Access Compliance Report

Public Rights-of-Way

(Curb Ramps)

Intersection ID: 42756	Main Street: CALDWELL_FOREST_DR	Cross Street: CALDWELL_RIDGE_PY	Location:	N
ADA ID: 3F6F70BA7860	Ramp Type: PerpDiag	Initial Pass/Fail: Fail	Overall Compliance: No	Severity Score: 13.75

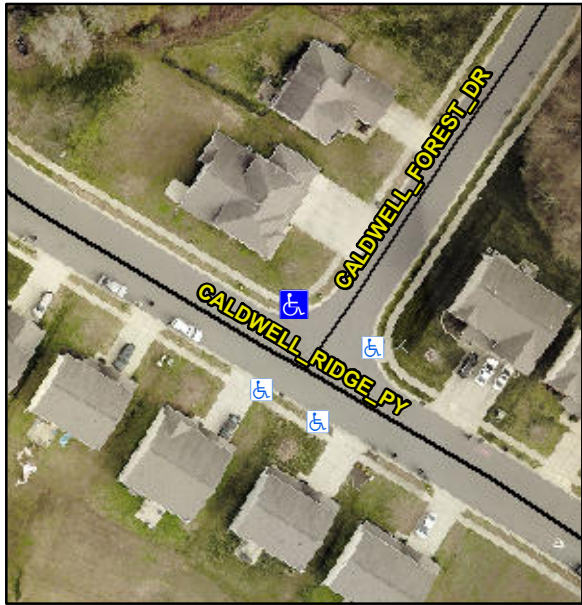
Codes/Mitigation Info/Possible Solution			Field Measurements/Component Compliance					
 <div>Street 1 Name Stop Condition-Street 2 Street 2 Name Stop Condition-Street 1</div>	Possible Solutions:		Compliance			Compliance		
	Remove & Replace Curb Ramp With Two New Directional Ramps or Equivalent.		Description			Description		
			Data			Data		
			N/A			No		
			Yes			No		
			N/A			N/A		
			N/A			N/A		
			N/A			N/A		
			N/A			N/A		
			N/A			N/A		
Surveyor Notes:								
N/A								
PROW/ADA:								
Not Found, R304.2.2, R304.5.3								
Total Cost:		\$ 3200.00

Compliance			Description			Data			Compliance			Description			Data		
N/A			Ramp Length (in)			57.0			No			Ramp Slope (%)			10.1		
Yes			Ramp Width (in)			50.5			No			Ramp XSlope (%)			4.6		
N/A			Flare Type LT			N/A			N/A			Flare Type RT			N/A		
N/A			Flare Slope LT (%)			N/A			N/A			Flare Slope RT (%)			N/A		
N/A			Flare Traversable LT?			N/A			N/A			Flare Traversable RT?			N/A		
N/A			Landing Length (in)			N/A			N/A			DWS Provided?			N/A		
N/A			Landing Width (in)			N/A			N/A			DWS Contrast?			N/A		
N/A			Landing Slope (%)			N/A			N/A			DWS Length (in)			N/A		
N/A			Landing X Slope (%)			N/A			N/A			DWS Full Width?			N/A		
N/A			Landing Curb? (Y/N)			N/A			N/A			DWS Offset (in)			N/A		
N/A			Shared Landing?			N/A											
N/A			Gutter Ponding?			N/A			N/A			Gutter Slope (%)			N/A		
N/A			Gutter Lip Ht (in)			N/A			N/A			Gutter X Slope (%)			N/A		
N/A			Painted X Walk1?			No			N/A			Painted X Walk2?			No
